Subject: LOt 17-A-@, Pappe Addition (G14-D087)

Shawn, I have received the updated site plan for the subject project but still have the following comments:

3440 2ND STREET, NW SITE PLAN FOR BUILDING PERMIT			
DRAWING:	DRAWN BY:	DATE:	SHEET#
 201424-SP.DWG	SH-B	10-05-2014	C101

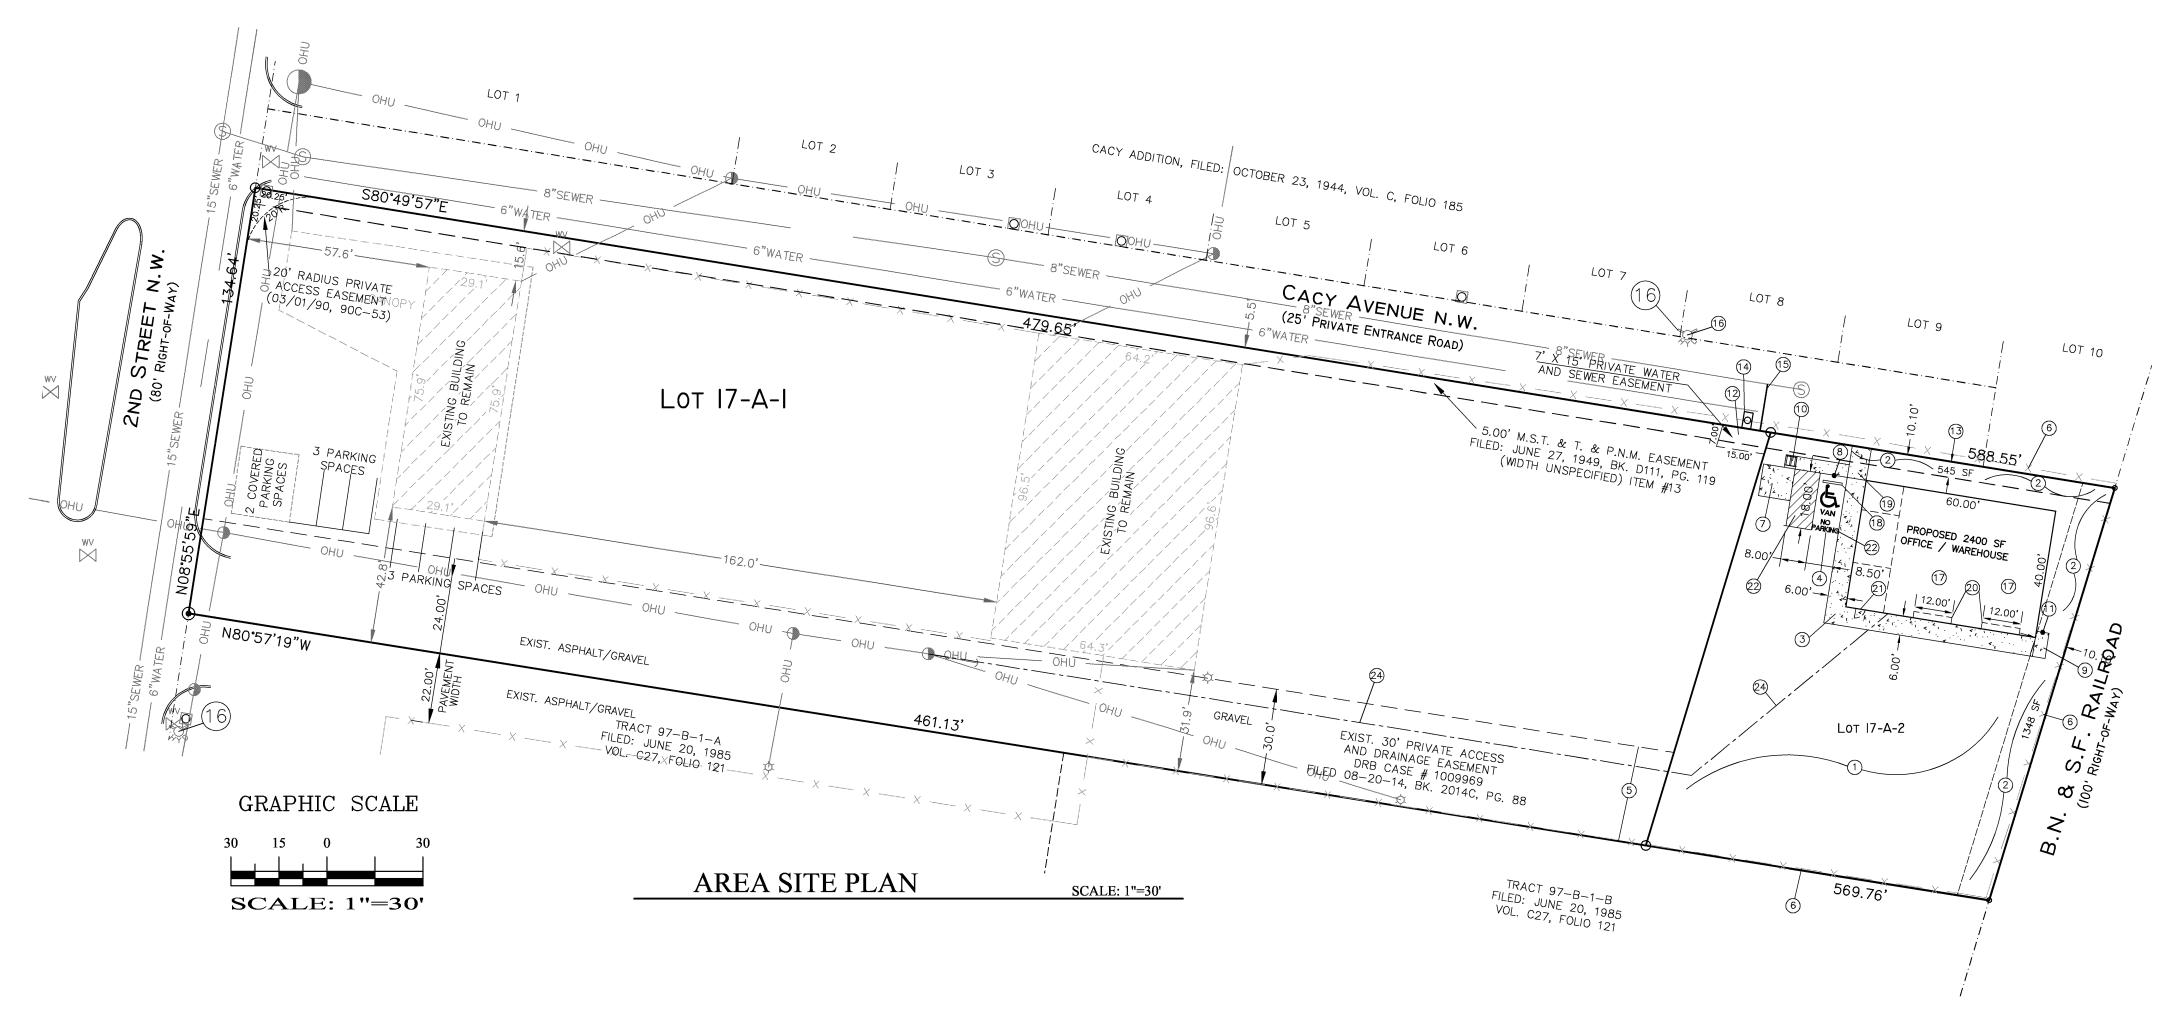
- 1. I do not see Keyed Note 23 on the plans. I think you meant to put in Keyed Note 23 where keyed note 22 is shown for the van accessible space.
- 2. The site plan needs to be clear that both the van accessible space and the handicapped space are asphalt. Right now only the handicapped space is shown to be asphalt. It may be more clear if some type of hatching/lineweights are shown to differentiate the asphalt area from the remaining area.
- 3. The "No Parking" words need to be placed in the van accessible aisle, not where the handicapped people park (See attached scan).
- 4. Also see the attached scan for exact required language on the handicap sign. The "van only" sign needs to be shown as "van accessible".

Feel free to e-mail me the revised site plan before coming in with two hard copies for my signature for this next goaround.
